GREAT RIVER
ENERGY®

**RE: Amendment to Great River Energy Application of August 31, 2012 for
Transmission Facility Certificate of Corridor Compatibility and Route Permit
Prairie Substation to Ramsey Substation 230 kV "GD" Transmission Line
Docket # PU-12-398**

Figure 4-1: Exclusion & Avoidance Areas for Corridor Section & Route ROW Amended

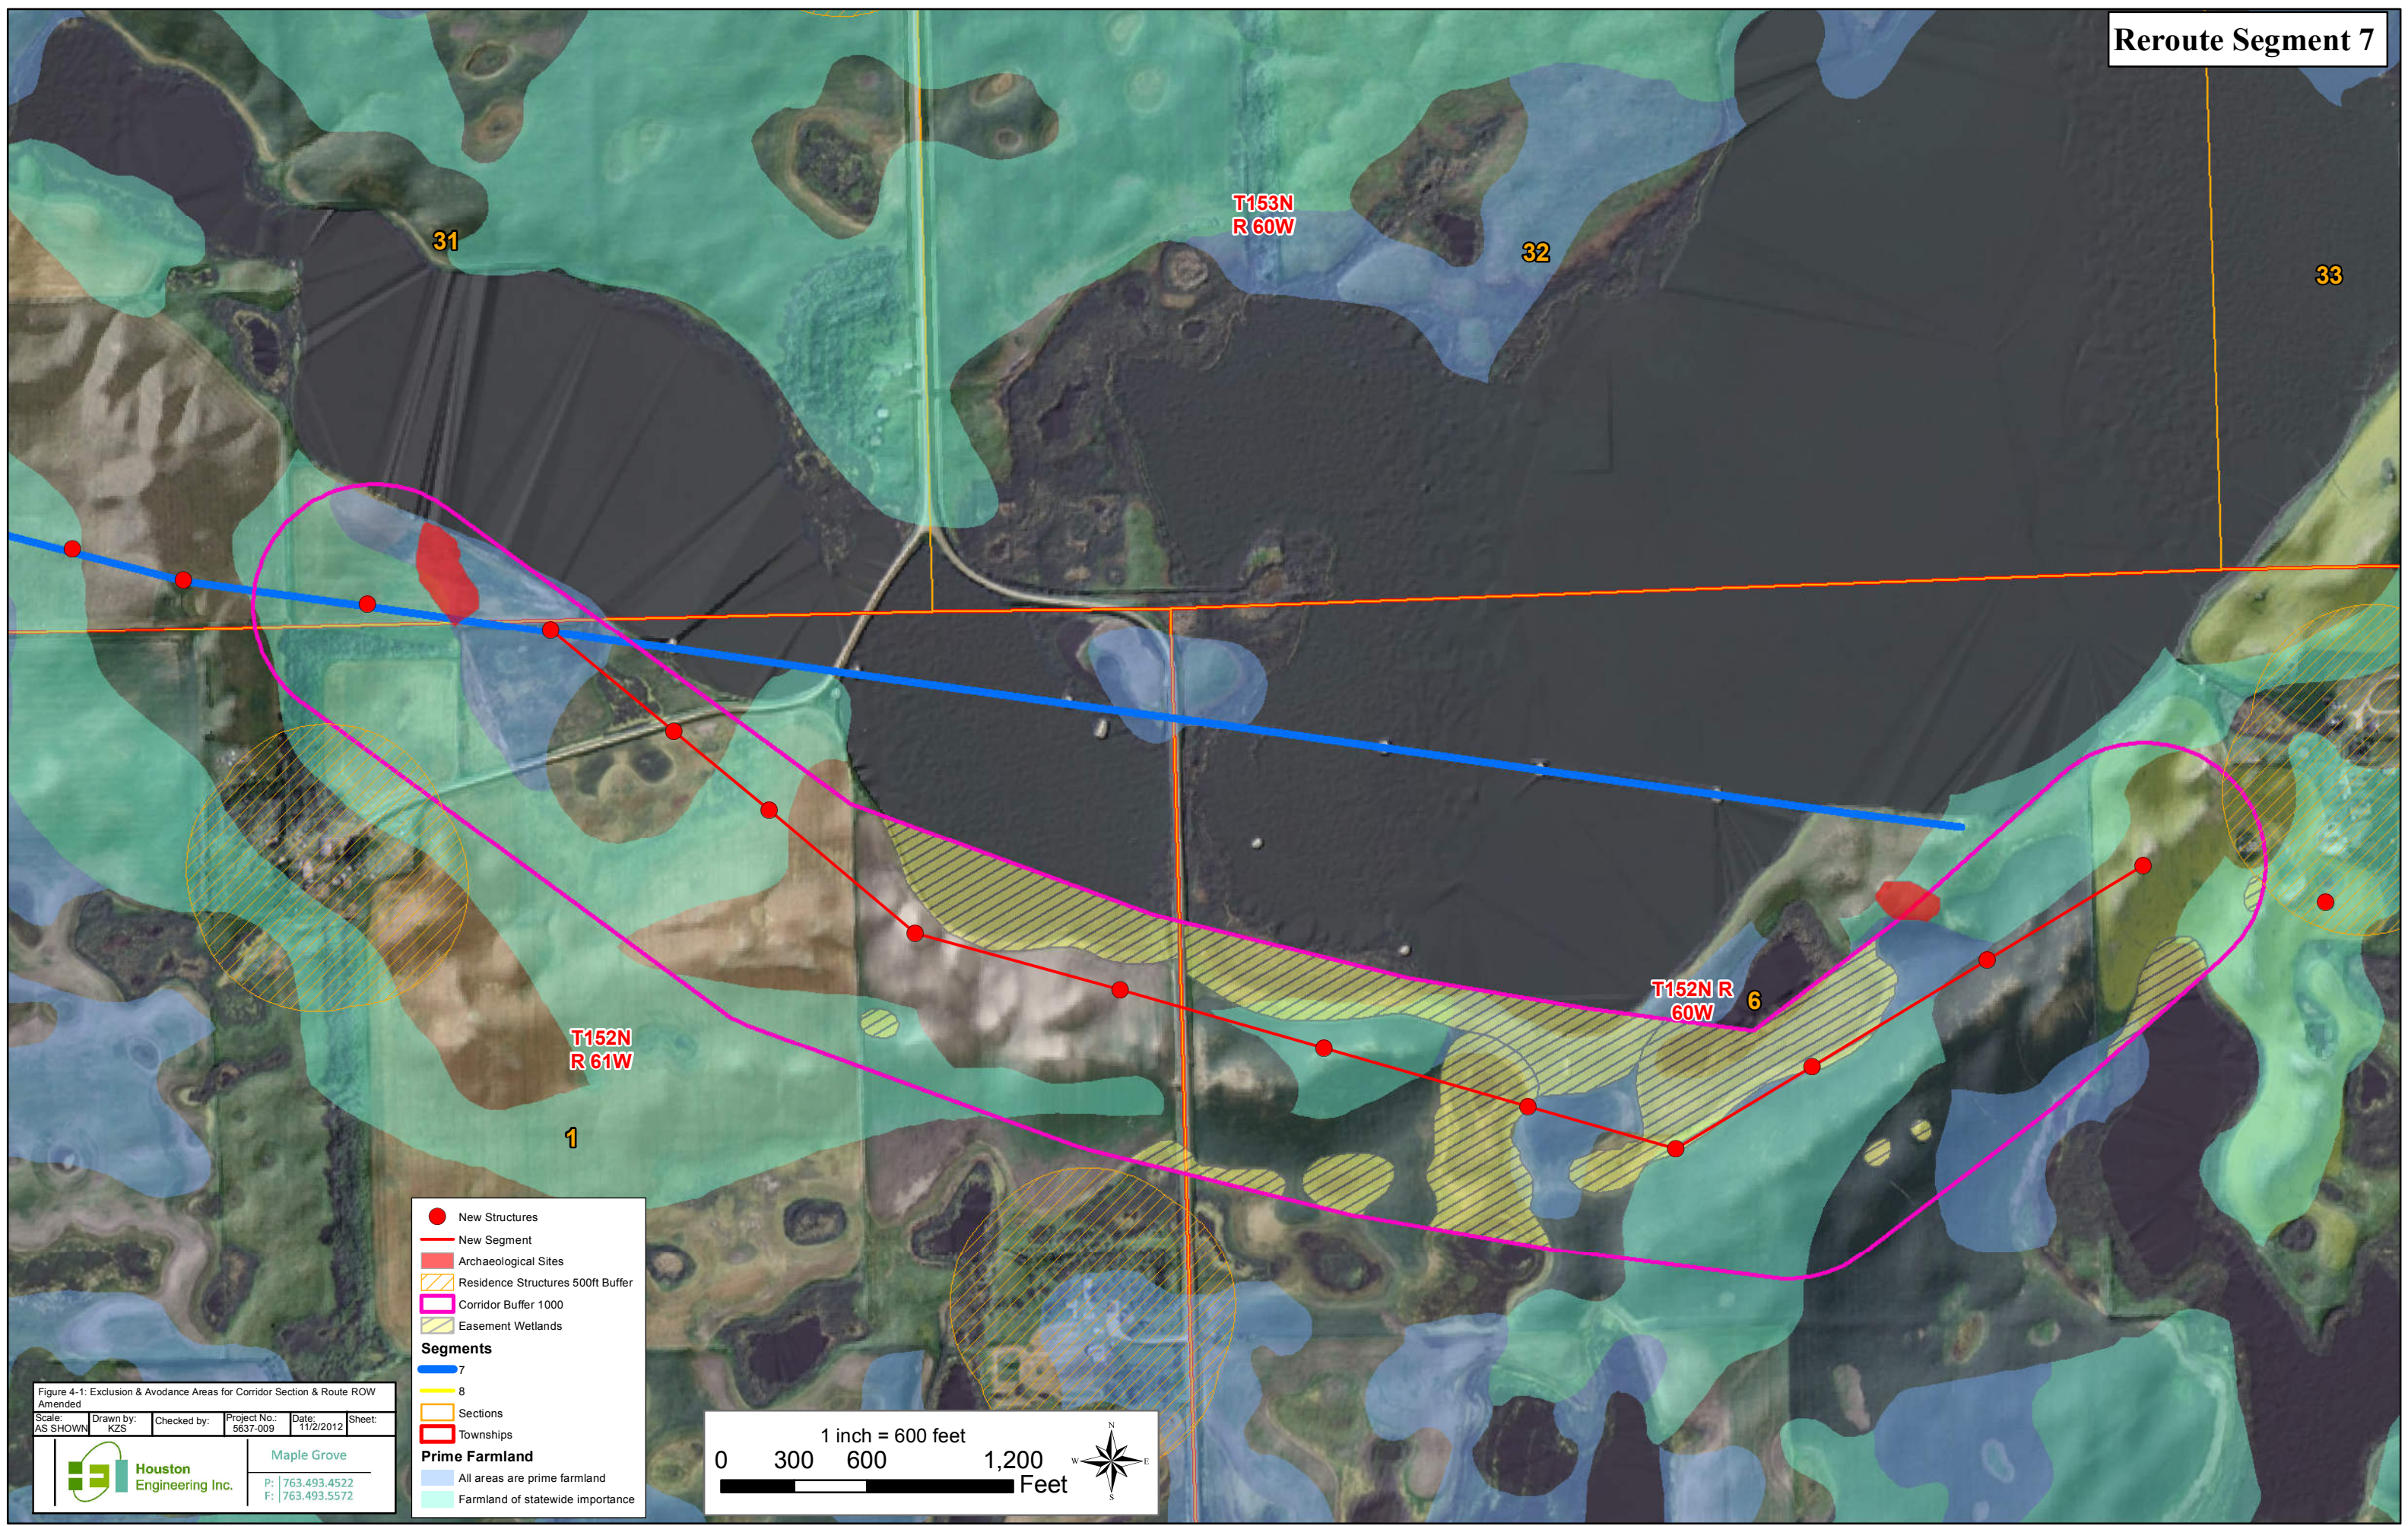
Figures 4-1 and 4-2 (attached) have been amended to represent the updated reroute right-of-way and pole structure locations. The adjustments to the Crary site reroute occurred on the north and eastern sides to avoid prime agricultural land and US Fish and Wildlife Service (USFWS) easement wetlands. The adjustments to the Lakota site reroute occurred as a result of Great River Energy working with landowners and Agency staff to further avoid impacts to prime agriculture land and USFWS easement wetlands.
